**World Forum for Harmonization of Vehicle Regulations****Working Party on Automated/Autonomous and Connected Vehicles****Twenty first session**

**Advanced Driver Assistance Systems and UN Regulation No. 79:  
Acceleration Control for Pedal Error****Proposal for the 01 series of amendments to UN Regulation  
on Acceleration Control for Pedal Error (ACPE)****Submitted by the experts from the Informal Working Group on  
Acceleration Control for Pedal Error\***

The text reproduced below was prepared by the Informal Working Group on Acceleration Control for Pedal Error (ACPE).

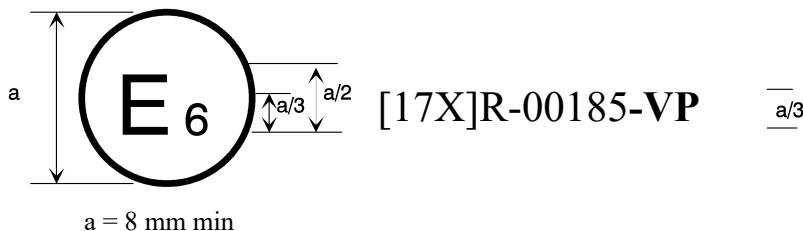
Annex 2, amend to read (addition of a letter "VP" in the marking and its reference in the text):

The above approval mark affixed to a vehicle shows that the vehicle type concerned has been approved in Belgium (E 6) with regard to the Acceleration Control for Pedal Error (ACPE) pursuant to UN Regulation No. [17X] (**marked with V for Vehicle and Wall. P for Pedestrian**). The first two digits of the approval number indicate that the approval was granted in accordance with the requirements of UN Regulation No. [17X] in its original form.
